ASSESSMENT REPORT

Mixed Use Development – 1 Lawson Square, Redfern SSD 5249 MOD 5

Figure 3: Proposed layout of roof terraces (Source: Amended MOD 5 architectural plans)

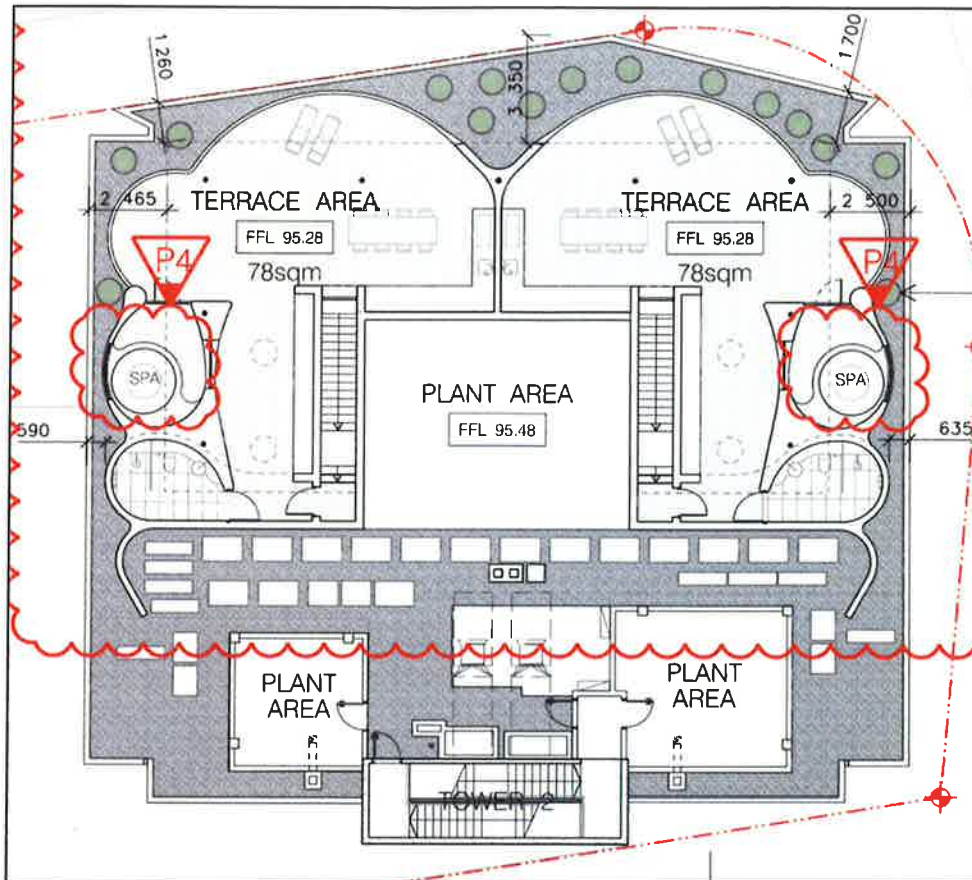
The terraces would have an area of 78sqm each and would be accessed via internal staircases to the apartments on the level below. They would adjoin and surround the approved rooftop plant area which will occupy the centre and southern part of the roof.

As initially proposed they included a small internal bathroom adjoining the plant room in the centre of the building and a lightweight zinc roof sheeting canopy open on the western, northern, and eastern elevations. The terraces would be set back from the edge of building at variable distances, with plants proposed to be provided in large, glass reinforced concrete pots beyond the balustrade within the setback area

- a curvilinear design to the walls and balustrading rather than a rectilinear form as originally proposed
- relocation of proposed bathrooms to the outer edge of the terrace
- addition of a spa to each terrace at the outer edge
- reduction in the minimum setbacks to the building edge
- provision of enclosing walls around the proposed spas and bathrooms on the eastern and western elevations.

Figure 4: Proposed roof plan (Source: Amended MOD 5 architectural plans)

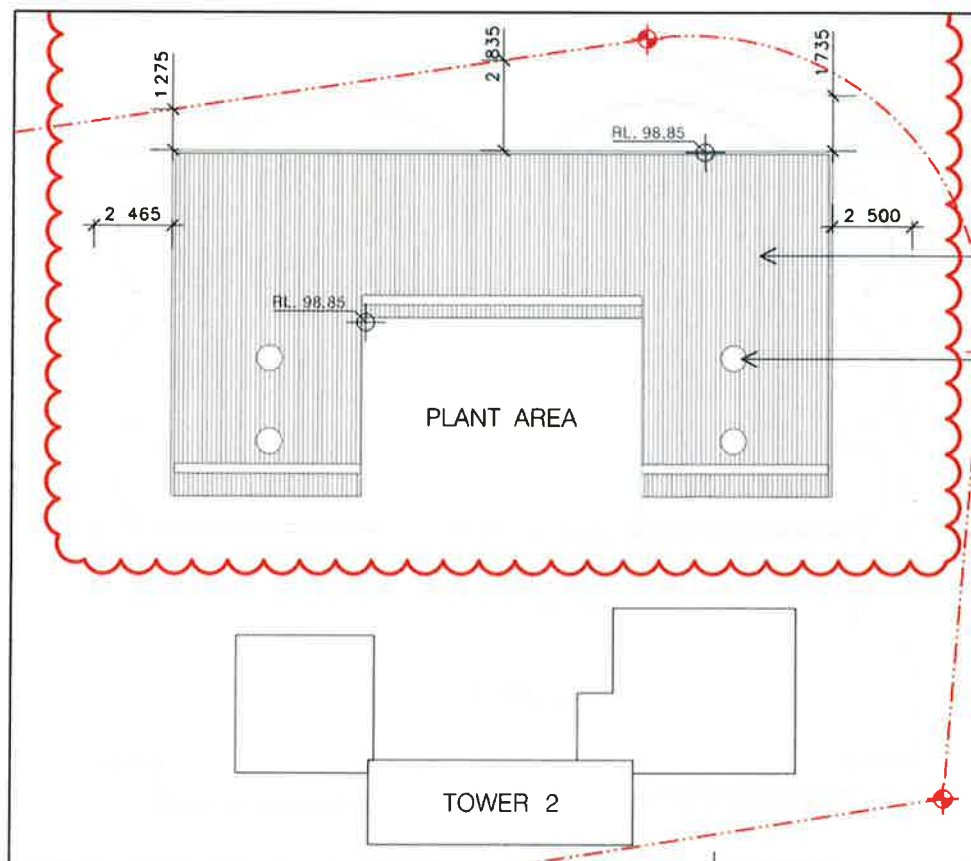
The proposed roof over the terraces would have a maximum height consistent with the height of the plant area. The proposed bathrooms and spas result in a minor increase in floor space by 20sqm from 12,973sqm to 12,993sqm.

Figure 5: Proposed northern (front) elevation (Source: Amended MOD 5 architectural plans)

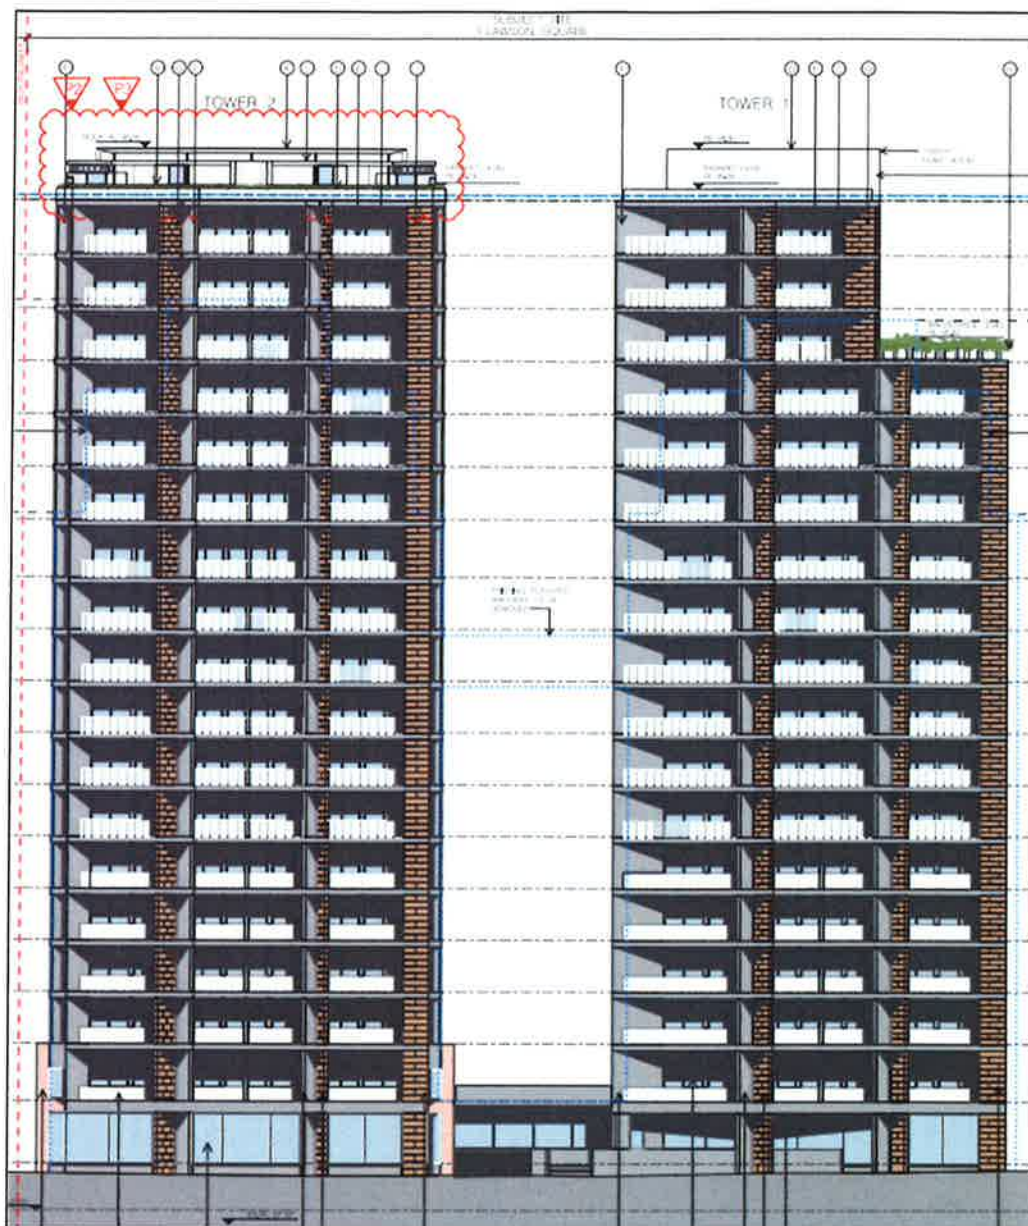
Visual Impacts	• The proposed changes to the roof level would result in a minor increase to the height and scale of the building when viewed from a distance. • The roof canopy would be the most visible aspect. However, it would be a lightweight structure, with a maximum height consistent with the plant rooms, generally open in appearance and setback on average 2.4 m from the building edge. • Apart from the roof canopy, the curvilinear walls around the bathrooms and spas would be visible from some vantage points, predominantly from the east. However the proposed walls would also be setback from the building edge, would be lower in height than the roof canopy and plant rooms and would be constructed of materials to complement the existing building. • The Department considers that as the proposed structures would be set back from the building edge they would not be dominant visual elements, would not detract from the design excellence qualities of the	No additional comments or amendments necessary

approved building, and would not have any impact for the overall character of the area. - The proposed changes would also improve the architectural quality of the roof level, obscuring views of the approved plantrooms with new curvilinear walls, an architectural roof form and plantings. - The Department therefore considers the proposed structures would make a positive contribution to appearance of the building.	
<i>Shadowing</i>	- The Applicant submitted shadow diagrams to demonstrate the shadowing effects of the proposed modification. - Shadows cast from the proposed roof terrace structures would fall predominantly on to the southern part of the roof of the approved development and for the majority of the day would not affect any adjoining development. - In the mid-late afternoon at midwinter the proposal would result in a nominal amount of additional shadows cast to the west of the site. - Council recommended investigating whether a reduced room form would reduce or eliminate the increased overshadowing effects. - The Department has considered the shadows and notes the area of additional shadow would not be perceptible in the context of shadowing from the approved building and would predominantly be within areas already in shadow from other surrounding buildings. - The shadowing impacts are therefore considered to be negligible and of no consequence, and no amendments to the roof form are required.	No additional comments or amendments necessary
